NUREG-2153
Volume 1

Final Safety Evaluation Report for Combined Licenses for Virgil C. Summer Nuclear Station, Units 2 and 3

Office of New Reactors

Figure 2.4-3. Plant Site Drainage Basins and Flow Paths (FSAR Figure 2.4.-261)
Subbasin 5 was designated by staff for examination of flow effects at the storm water basin in Subbasin 4

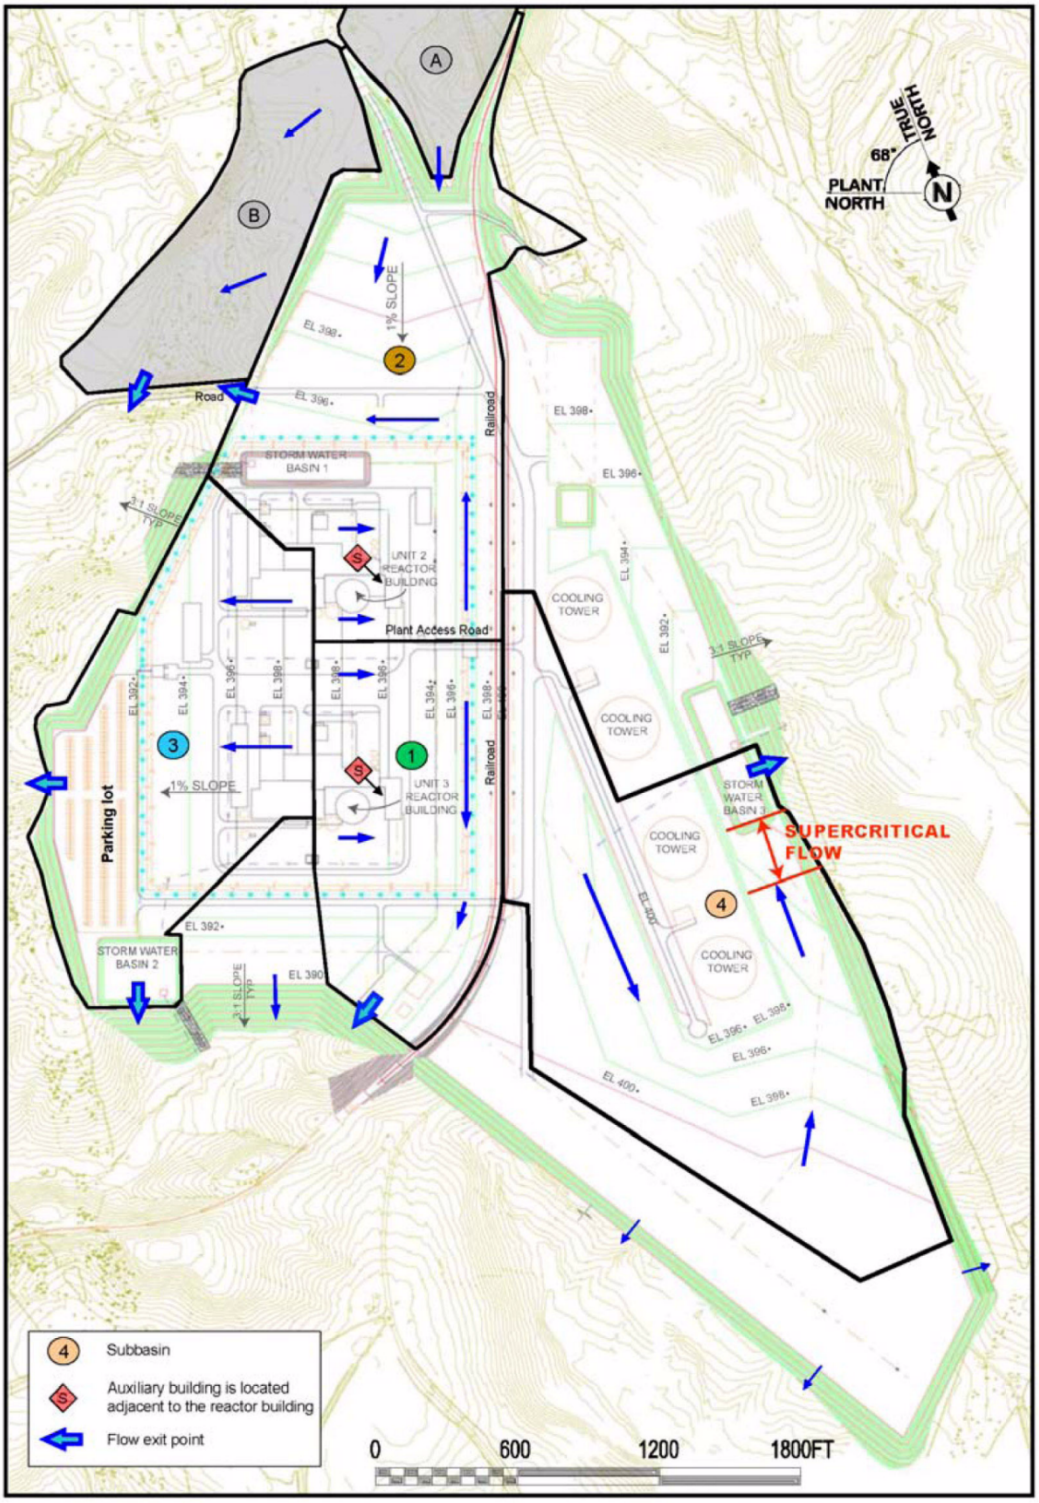
The railroad line coincides with the flow divide for Subbasins 1 and 4. The power block area forms another significant divide for subbasins 1 and 3 as well as Subbasins 2 and 3. An additional drainage area (Subbasin 5) was used by the NRC for the examination of flow effects at Storm Water Basin 3 within Subbasin 4. This additional drainage area is depicted in SER Figure 2.4-3, "Plant Site Drainage Basins and Flow Paths."

Figure 2.5.1-1. Map of Physiographic Provinces and Mesozoic Rift Basins

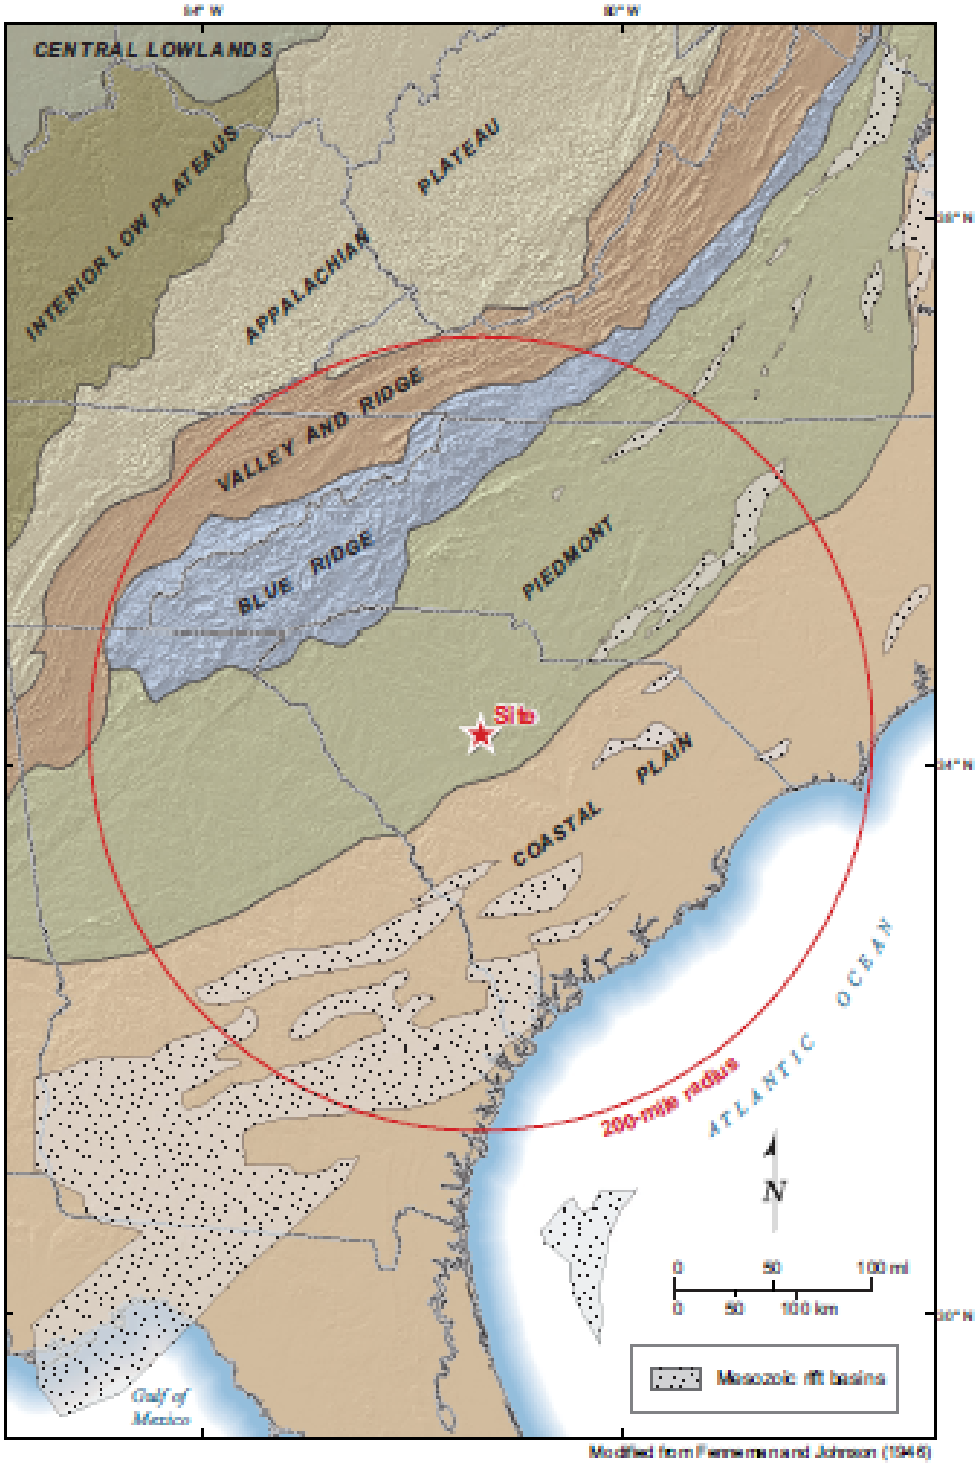
VCSNS COL FSAR Section 2.5.1.1.1 describes the regional physiography, geomorphology and stratigraphy in relation to the five physiographic provinces which occur in the VCSNS site region. SER Figure 2.5.1-1, reproduced from VCSNS COL FSAR Figure 2.5.1-201, shows the location of the VCSNS site and its spatial relationship to those portions of the Appalachian Plateau, Valley and Ridge, Blue Ridge, Piedmont, and Coastal Plain physiographic provinces within the site region. The VCSNS site is located in the Piedmont physiographic province.

In VCSNS COL FSAR Section 2.5.1.1.1, the applicant described regional physiography, geomorphology, and stratigraphy in relation to the five physiographic provinces which occur in the site region (SER Figure 2.5.1-1, reproduced from FSAR Figure 2.5.1-201). The applicant stated that the VCSNS site is located in the Piedmont physiographic province approximately 32 km (20 mi) northwest of its boundary with the Coastal Plain province (SER Figure 2.5.1-1), lying specifically in the Charlotte lithotectonic terrain of the Carolina Zone of the Piedmont province.

Figure 2.5.1-2. Potential Quaternary Features in the Site Region

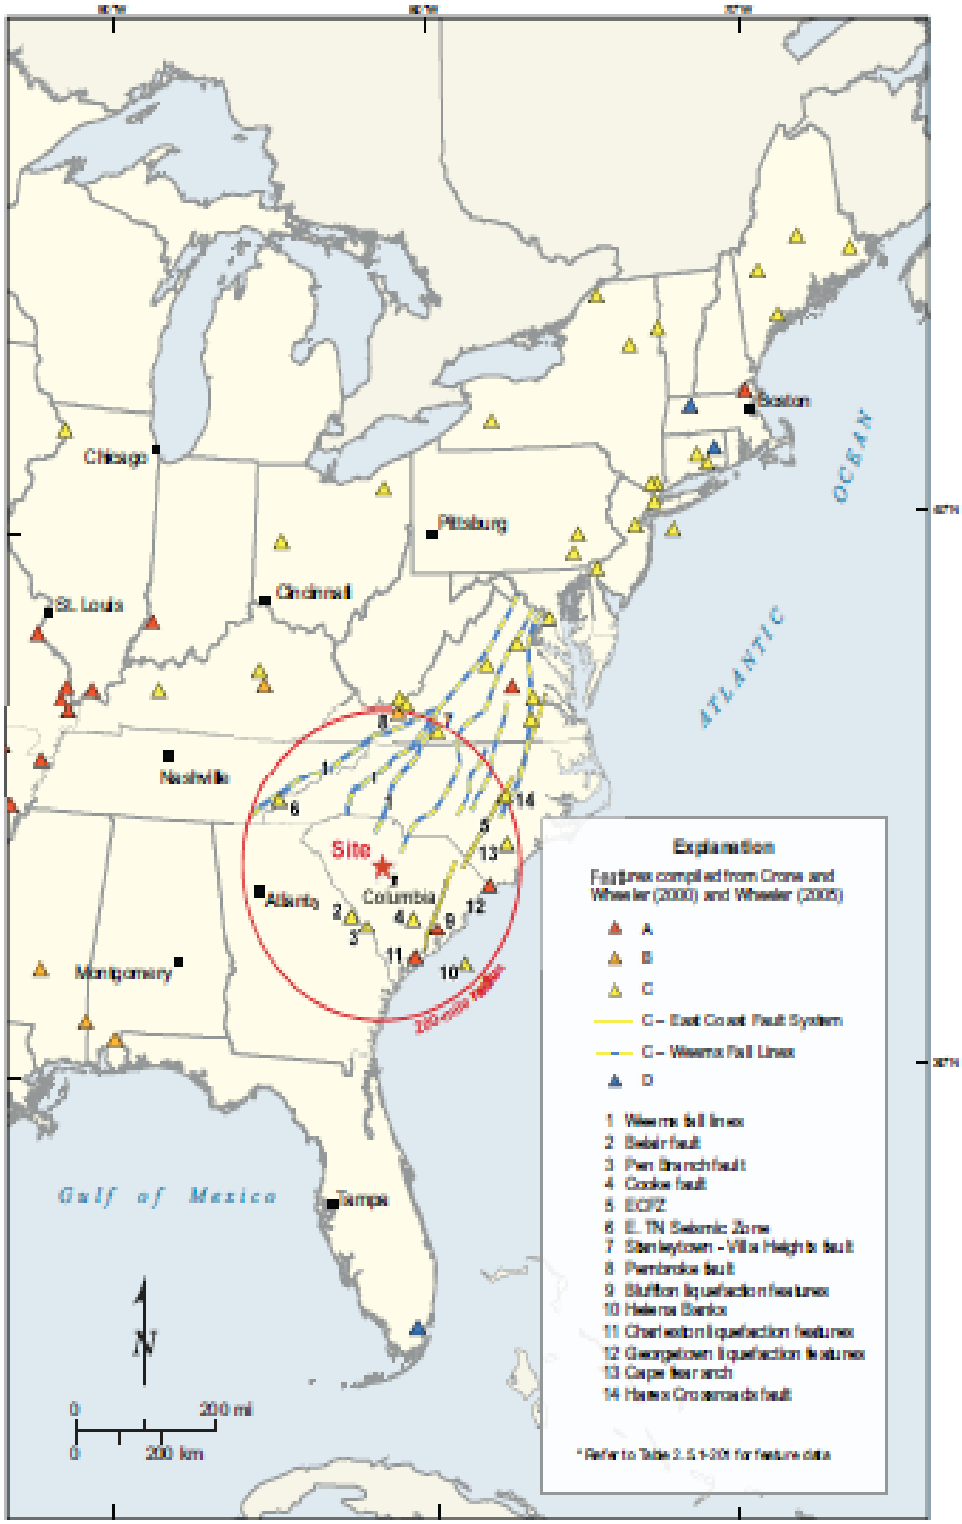
The applicant noted that the Pen Branch fault is more than 32 km (20 mi) in length and located 113 km (70 mi) south-southwest of the VCSNS site (SER Figure 2.5.1-2). The applicant stated that seismic reflection and borehole data collected at the Savannah River Site (Cumbest and others, 2000), as well as investigations performed for the Vogtle Electric Generating Plant (VEGP) ESP application (U.S. NRC, 2009), show no evidence of post-Eocene (i.e., < 33.9 Ma) deformation on the Pen Branch fault. Therefore, the applicant concluded that the Pen Branch fault is older than 33.9 Ma and is not a capable tectonic structure.

The applicant indicated that the Hares Crossroads fault was only recognized in a roadcut exposure approximately 320 km (200 mi) northeast of the VCSNS site (SER Figure 2.5.1-2). The applicant postulated that this feature likely resulted from land sliding, and is nontectonic in origin. Crone and Wheeler (2000) classified the Hares Crossroads fault as a Class C feature based on a lack of evidence for Quaternary (2.6 Ma to present) faulting.

Regional Quaternary Tectonic Structures. In VCSNS COL FSAR Section 2.5.1.1.2.4.4, the applicant listed 14 potential Quaternary (2.6 Ma to present) tectonic features which occur in the site region. Locations of the features are shown in SER Figure 2.5.1-2 (reproduced from FSAR Figure 2.5.1-215). Quaternary tectonic structures warrant the most detailed evaluation because the structures represent potentially capable tectonic features.

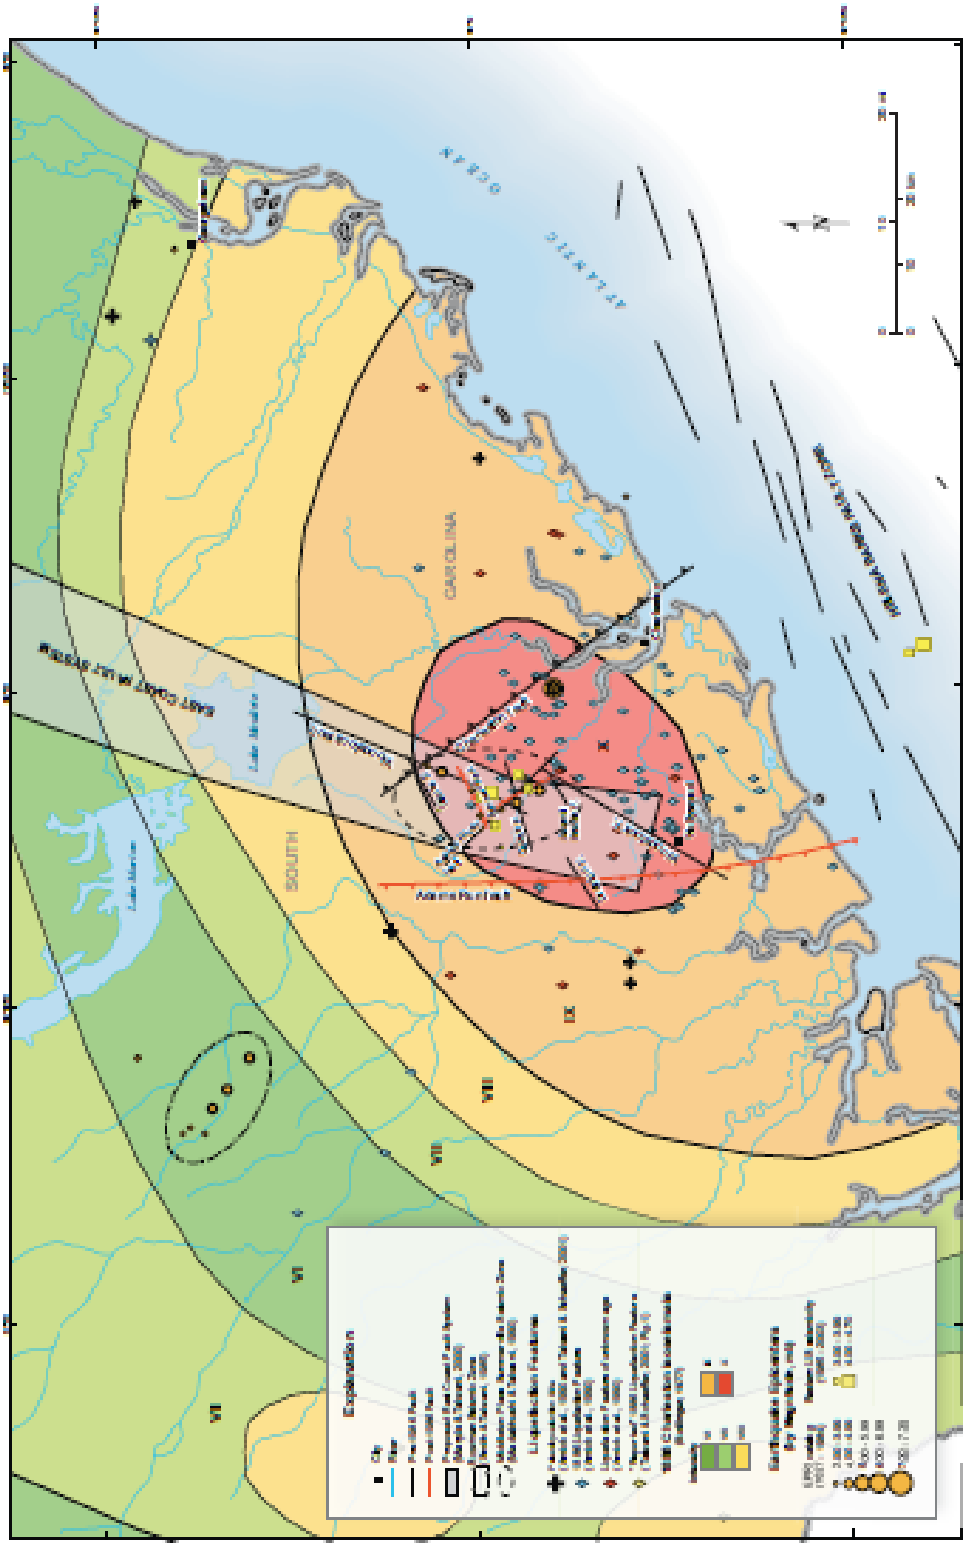
Charleston Seismic Zone. VCSNS COL FSAR Section 2.5.1.1.3.2.1 discusses the 11 buried potential causative source faults and fault zones for the 1886 Charleston earthquake, which have been postulated to occur in the Charleston area; the three seismic source zones defined for the Charleston area (i.e., the Middleton Place-Summerville, Bowman, and Adams Run zones); and the seismically-induced liquefaction features found in the Charleston area. Locations of the seismic source zones and the potential causative source faults and fault zones are shown in SER Figure 2.5.1-3.

The applicant described the Middleton Place-Summerville Seismic Zone as an area of high microseismic activity located about 19 km (12 mi) northwest of Charleston, South Carolina (SER Figure 2.5.1-3). The Bowman Seismic Zone is located approximately 80 km (50 mi) northwest of Charleston and lies outside the meizoseismal area defined for the 1886 Charleston earthquake (SER Figure 2.5.1-3). The applicant identified the Adams Run Seismic zone, located in the meizoseismal area of the 1886 Charleston earthquake about 185 km (115 mi) from the VCSNS site, on the basis of four **M**<2.5 earthquakes reported by Tarr and Rhea (1983) which occurred in that zone in a 2-day period during December 1977.

Figure 2.5.1-4. Seismic Zones and Seismicity in CEUS

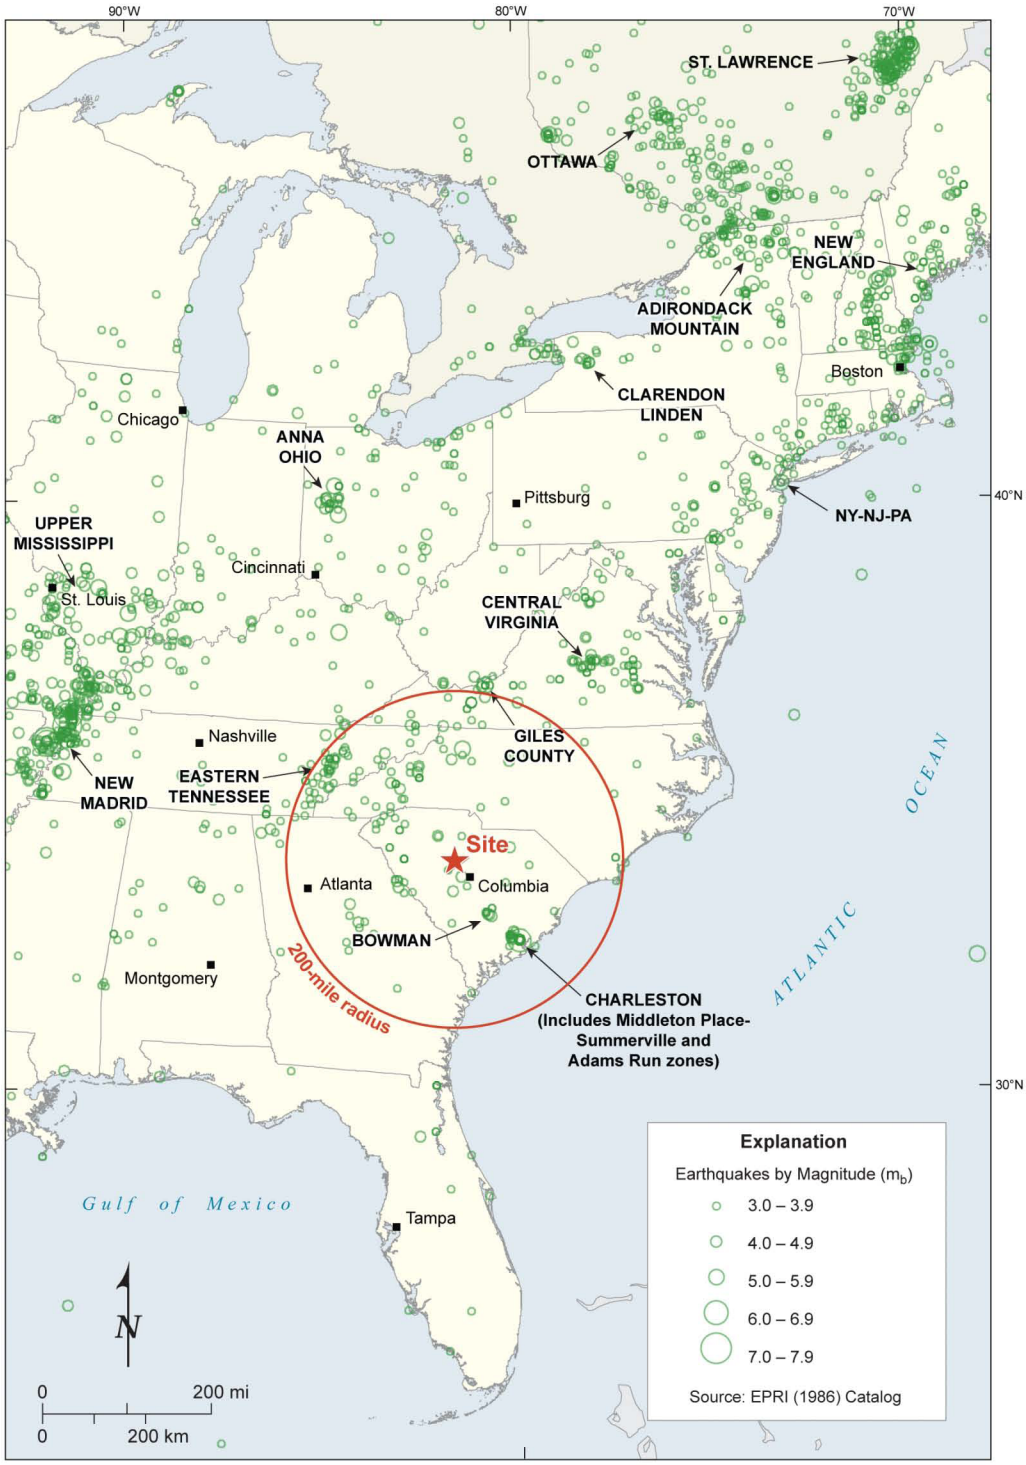
Seismogenic and Capable Tectonic Sources Beyond the Site Region. The applicant discussed three seismogenic and capable tectonic sources which lie outside the site region, namely the New Madrid, Central Virginia, and Giles County Seismic Zones (SER Figure 2.5.1-4).

In VCSNS COL FSAR Section 2.5.1.1.3.2.2, the applicant discussed the ETSZ, located approximately 282 km (175 mi) northwest of the VCSNS site as shown in SER Figure 2.5.1-4. Based on information provided by Chapman and others (2002), the applicant stated that the largest known earthquake in this zone was a magnitude 4.6, with magnitude scale unspecified. The applicant indicated that structures responsible for seismicity in the ETSZ are likely deep-seated Cambrian (542-488 Ma) or Precambrian (>542 Ma) normal faults reactivated in the present-day regional stress field, although seismicity in the zone cannot be attributed to any known fault.

In VCSNS COL FSAR Section 2.5.1.1.3.2.3, the applicant discussed three areas of concentrated seismicity outside the VCSNS site region, namely, the New Madrid, Central Virginia, and Giles County Seismic Zones. These three seismic zones are located in SER Figure 2.5.1-4.

Figure 2.5.2-1. Comparison of Events (m_b > 3) from the EPRI Historical Catalog (Depicted by Yellow Circles) with Events from the Applicant's Updated Catalog (Depicted by Green Circles)

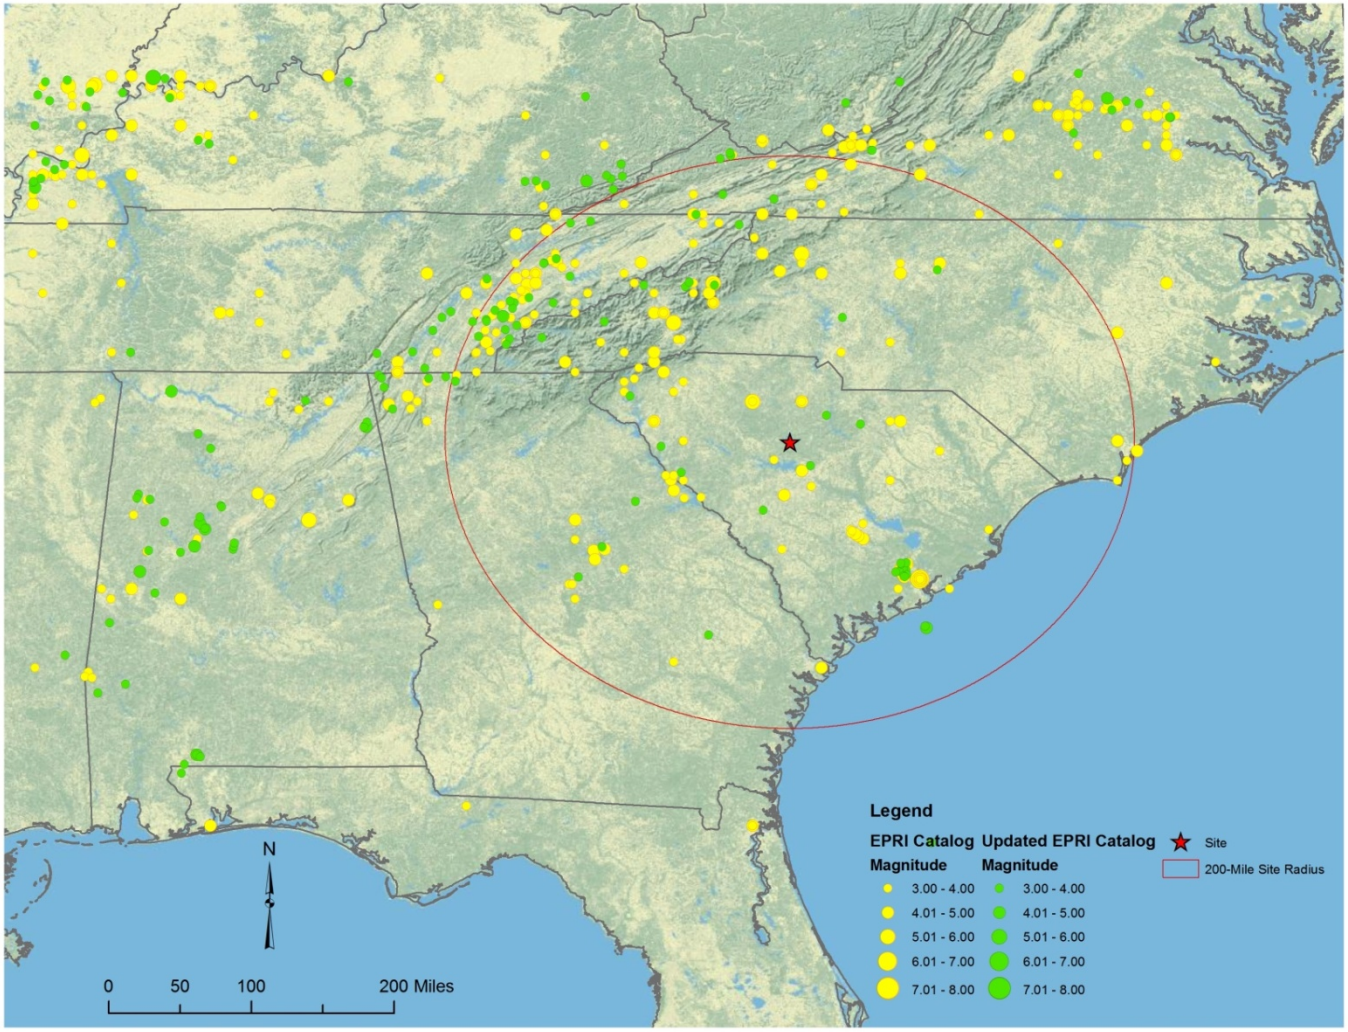
As shown in Figure 2.5.2-1 of this SER, a comparison of the geographic distribution of earthquakes in the EPRI catalog (1627-1984) and the earthquakes in the updated catalog (1985-2006) reveals a very similar spatial distribution. The cluster of events along the coast of South Carolina is related to the Charleston Seismic Zone, while the cluster of events in eastern Tennessee is associated with the ETSZ. The ETSZ extends from southwest Virginia to northeast Alabama. The NMSZ, although located well beyond the 320-km (200-mi) site radius, corresponds to the cluster of events stretching to the southwest from New Madrid, Missouri, to the western part of Tennessee and northeastern Arkansas.
